**RE: Response to Approval with Modifications
French Drain Soil Sampling Investigation Work Plan
Western Refining Southwest LLC, Marathon Gallup Refinery
EPA ID# NMD000333211
HWB-WRG-20-022**

ATTACHMENT A – RESPONSE TO COMMENTS

New Mexico Environment Department (NMED) to Marathon Petroleum Company (MPC) Comment Letter “Approval with Modifications French Drain Soil Sampling Investigation Work Plan” (January 8, 2021)

MARATHON PETROLEUM CORPORATION
GALLUP REFINING DIVISION
FRENCH DRAIN SOIL SAMPLING INVESTIGATION
WORK PLAN

- A. WELL LOGS
- B. STANDARD OPERATING PROCEDURE – SOIL SAMPLING

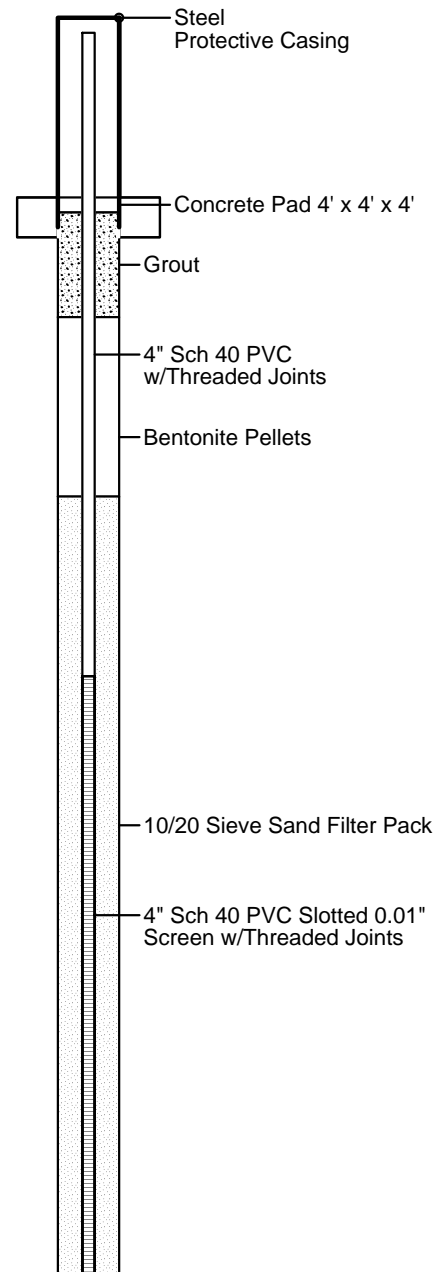
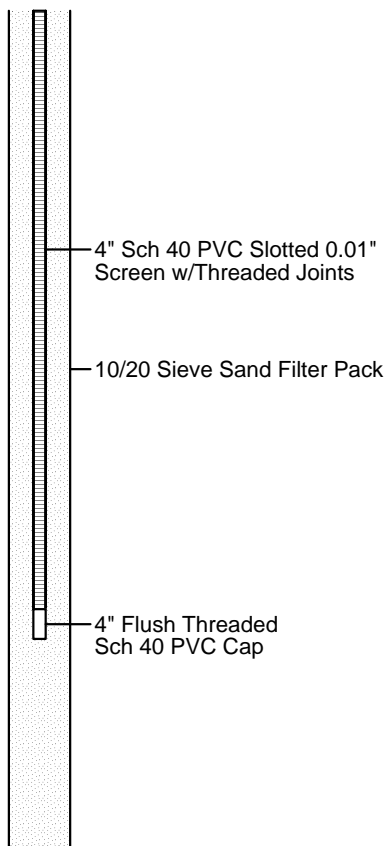
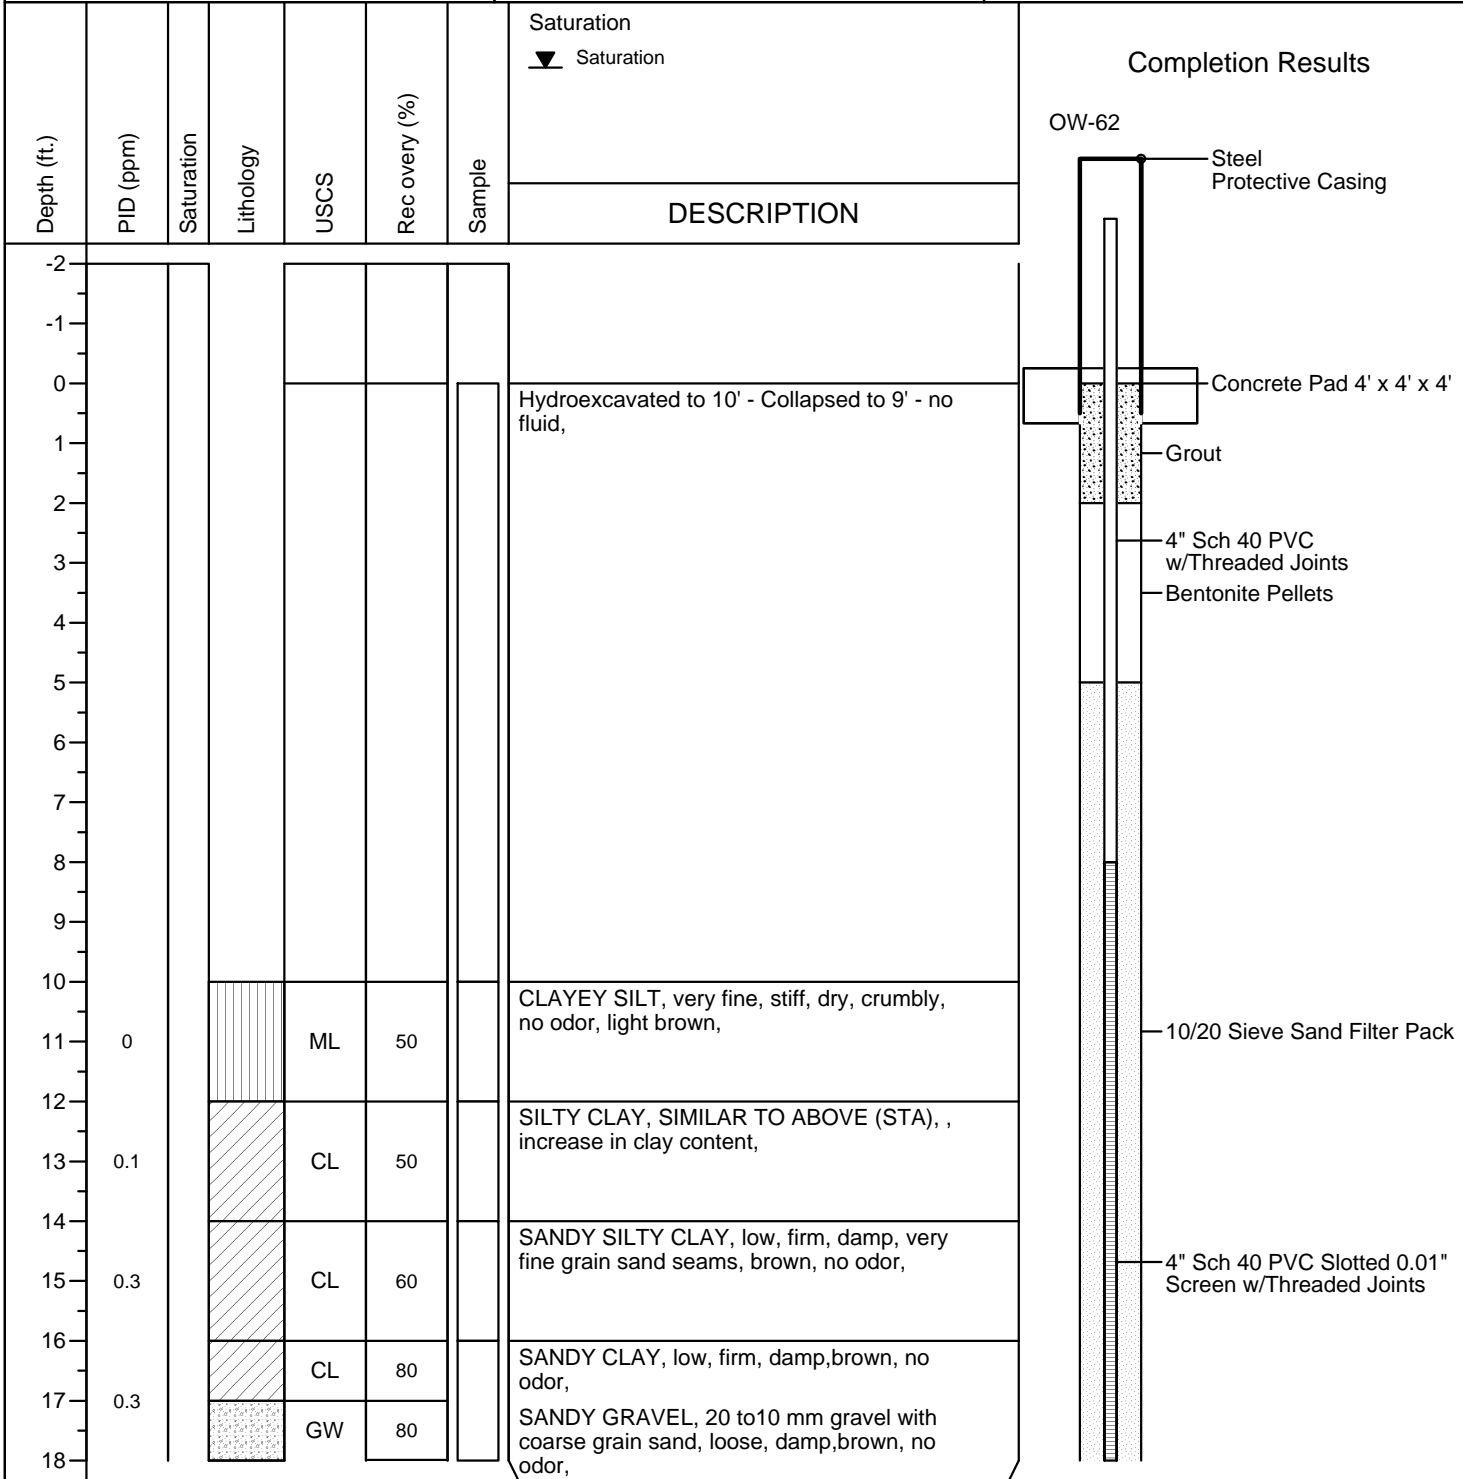
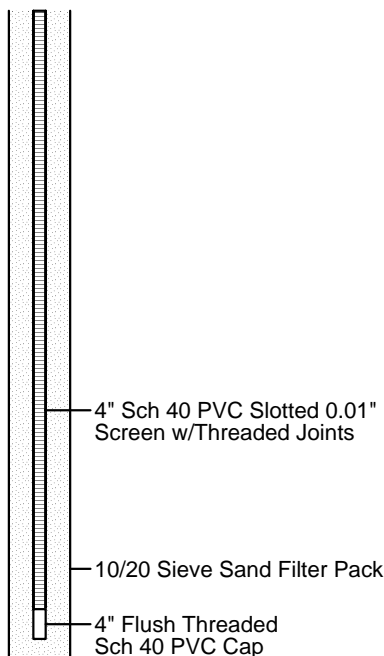
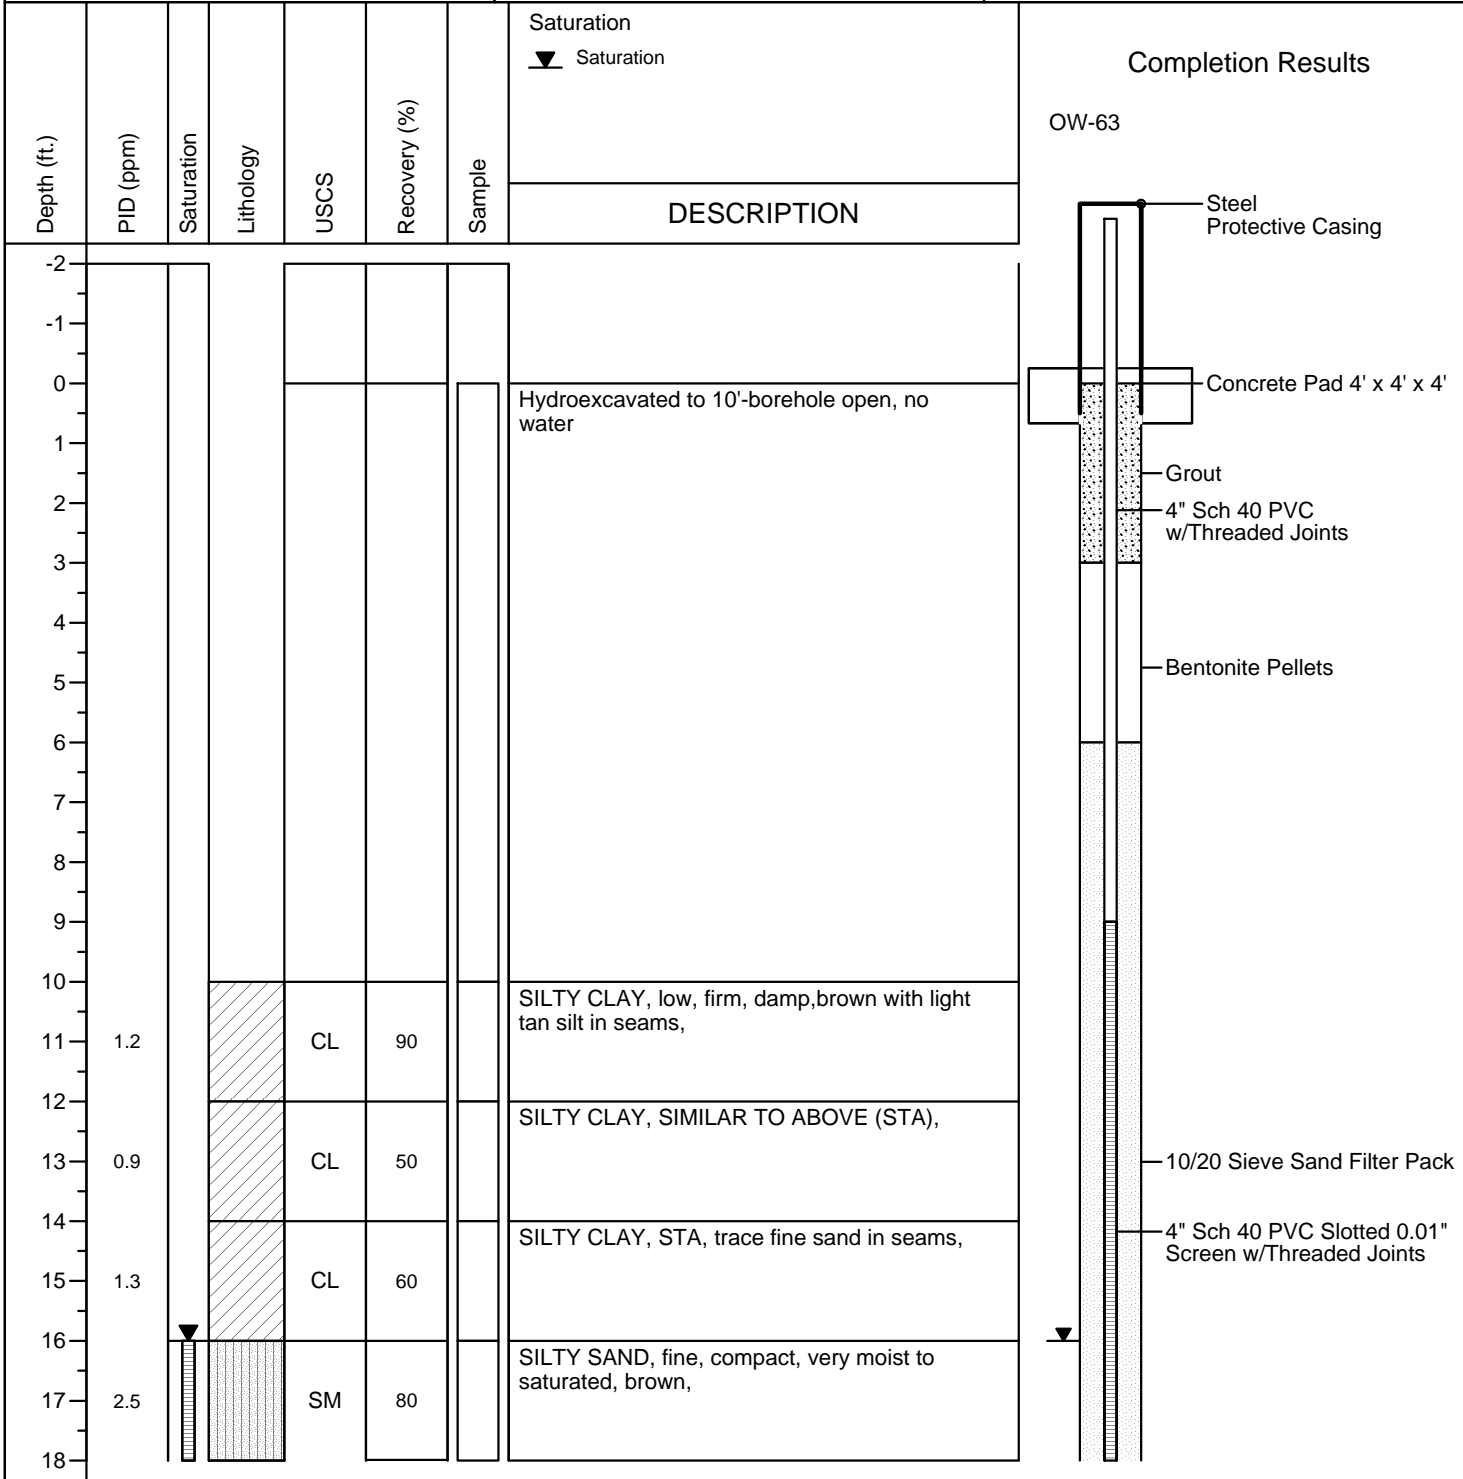
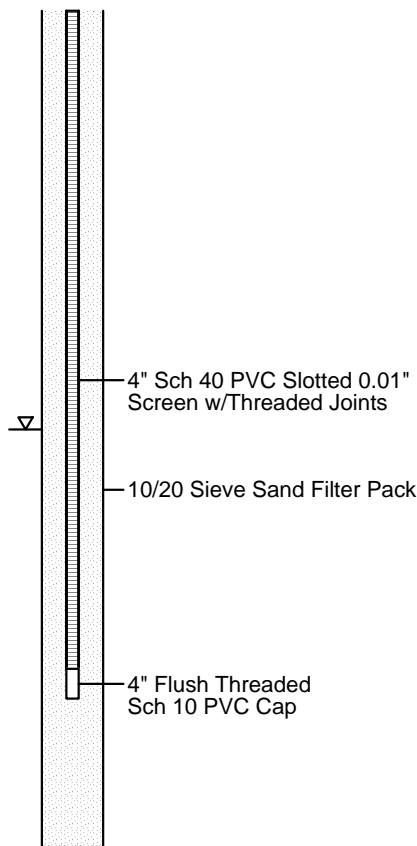
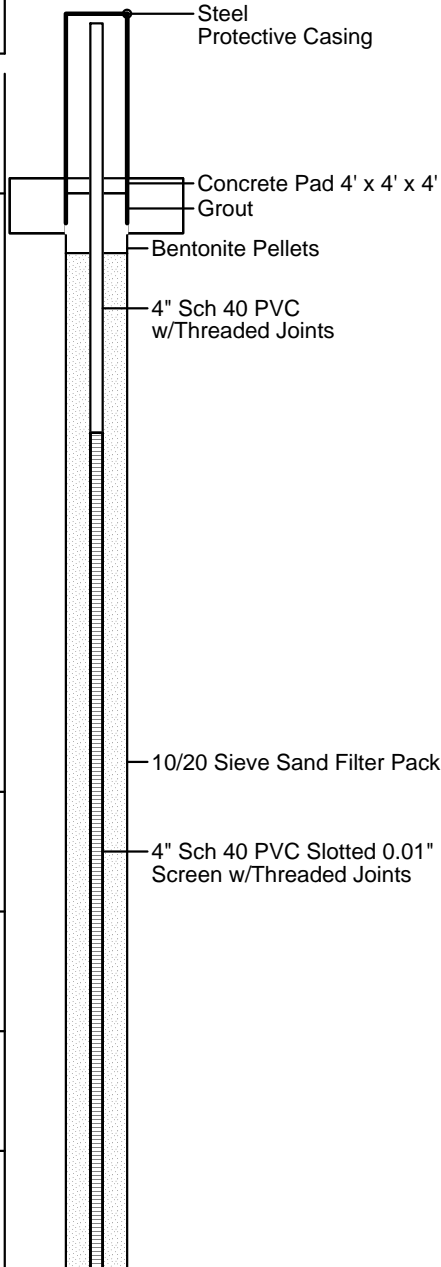
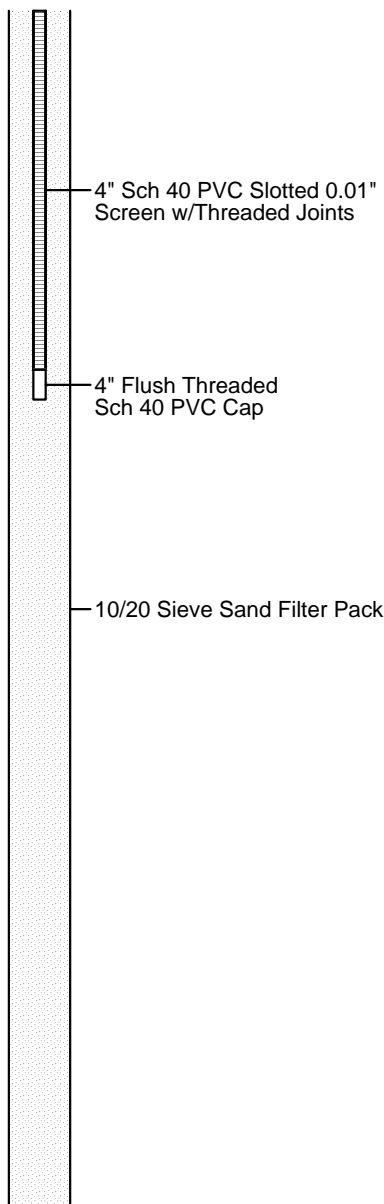
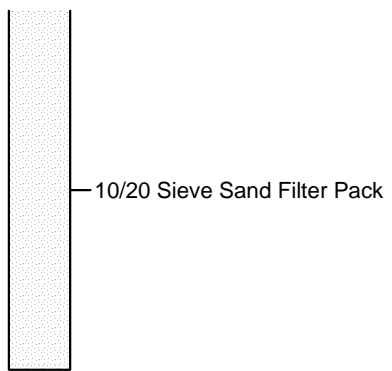
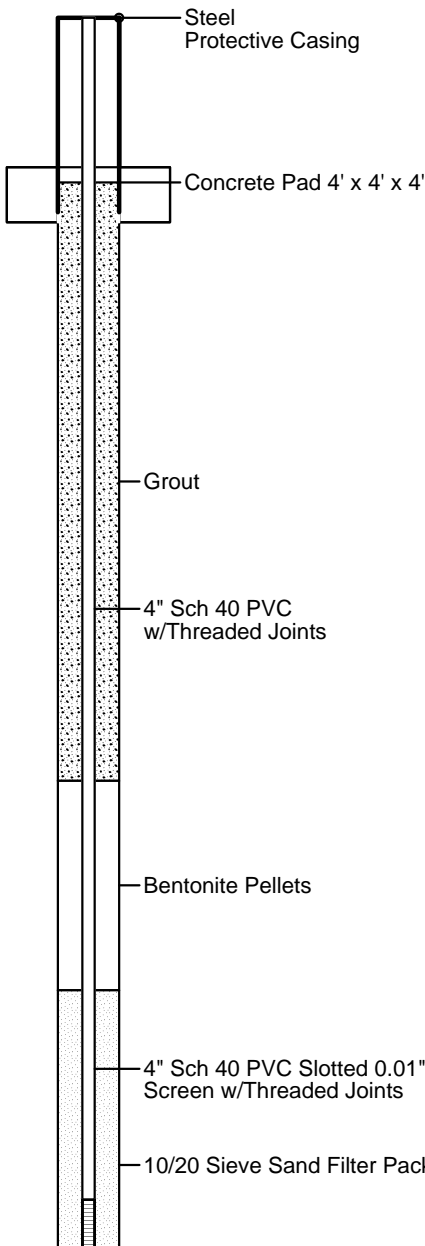
| NMED Comment | MPC Response |
|--|--|
| <p>Appendix A, <i>Well Logs</i>, does not include a boring log for SB-FD-1. In addition, Figure 3 does not depict any proposed borings north of STP-1 to investigate presence or absence of contamination associated with the French Drain release. Provide a boring log for SB-FD-1 and discuss whether (1) hydrocarbons were detected at location SB-FD-1 and (2) soil investigation is warranted north of STP-1 in the response letter.</p> | <p>2018 the drilling rig was set up on location SB-FD-1. Sample collection was accomplished using the HSA drilling method and split spoon samplers. No discrete soil samples were retained for laboratory analysis since the field screening results did not indicate potential contamination and the focus of this effort was the identification of SPH. The lithology encountered consisted of the following:</p> <ul style="list-style-type: none"> ▪ The 0 to 10 foot interval was not logged due to use of hydro excavation to clear the location; ▪ Silty Clay: 10 - 14 feet below ground level (bgl) (low plasticity, very stiff, dry to damp, reddish brown, calcareous at base no odor); ▪ Silty Clay: 14 - 24 feet bgl (low plasticity, firm/crumblly, damp, light reddish brown, very calcareous 15.75 — 16.0 feet, no odor, increase in silt lower 2 feet); ▪ Silty Clay: 24 - 38 feet bgl (low plasticity, very stiff, dry to damp, reddish brown with greenish gray color from 24 to 26 feet bgl, thin 1” sandstone lens at 25.75 feet and calcareous 34 to 36 feet bgl, no odor); <p>The boring was left open for two days but did not produce water and was plugged on March 9, 2018.”</p> <p>Figure 3, <i>Proposed Soil Boring Location</i>, does not depict any proposed soil borings north of STP-1 because the area was included in Sitewide LIF Investigation, completed during the week of May 10, 2021. The Sitewide LIF location figure is provided in Attachment C.</p> |
